Service Bulletin No. 459

| <small>MODEL</small> D Series | <small>TYPE</small> Field Change Program | <small>SECTION/GROUP</small> 8-Engine | <small>DATE</small> Jan. 26, 2018 |
| <small>SUBJECT</small> TAILPIPE AND BUMPER SHIELD | | | |

Figure 2.

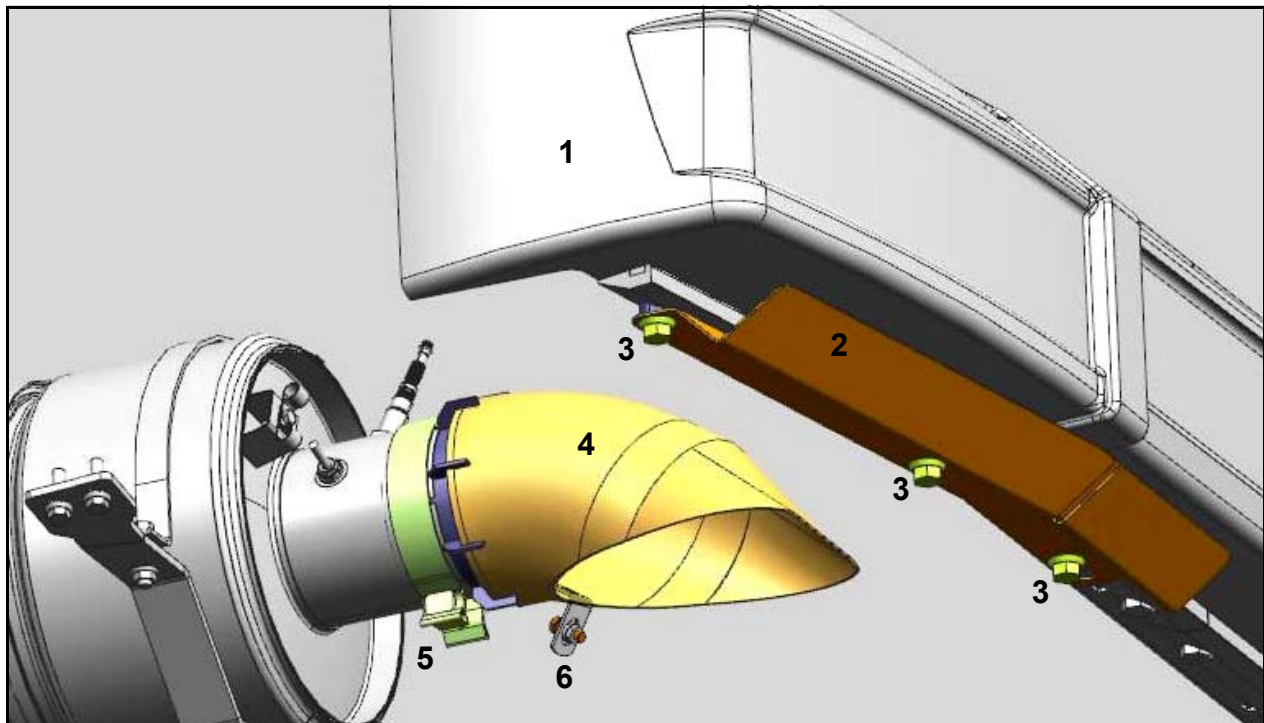
4. Remove and discard the existing tailpipe and mounting clamp.
5. Orient the shield assembly, p/n 03-21-1733, as shown in Figure 2 to identify the existing bumper bolts to be removed.

6. Remove and discard the three (3) identified bolts from the bottom of the bumper, required to mount the shield assembly. Orient the capscrews, p/n 19-01-1529, through the shield holes and position the spacers, p/n 19-05-0388, on top of the shield assembly and underneath the bumper. Align and mount assembly to the bumper using the existing nuts and clipnuts as shown in Figure 2. Torque capscrews to 45-50 ft-lbs.
7. Orient the new clamp, p/n 08-20-1561, and tailpipe, p/n 08-20-2728, to the exhaust outlet. Torque to 38-45 ft-lbs.

Figure 3. Tailpipe support bracket positioning.

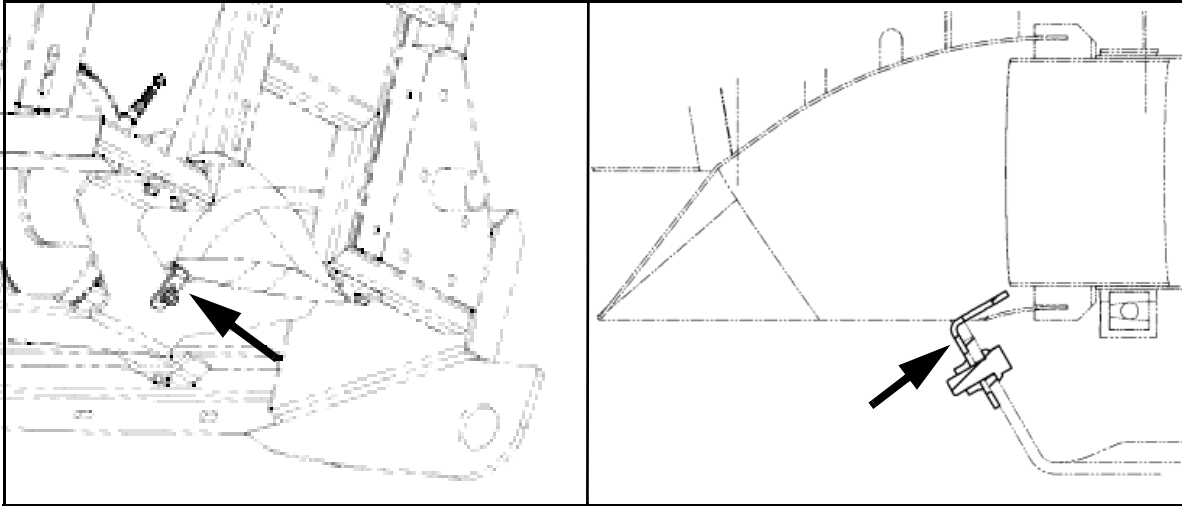
8. Orient and position the short flange of the bracket, p/n 08-01-1043, inside the tailpipe as shown in Figures 2 and 3. Using the hole in the bracket as a drilling template, mark the location of the hole with a scribe or marker.
9. Using a 0.438 drill bit, drill a hole. Secure the installation with the capscrew and locknut. Torque the locknut to 40-44 ft-lbs.
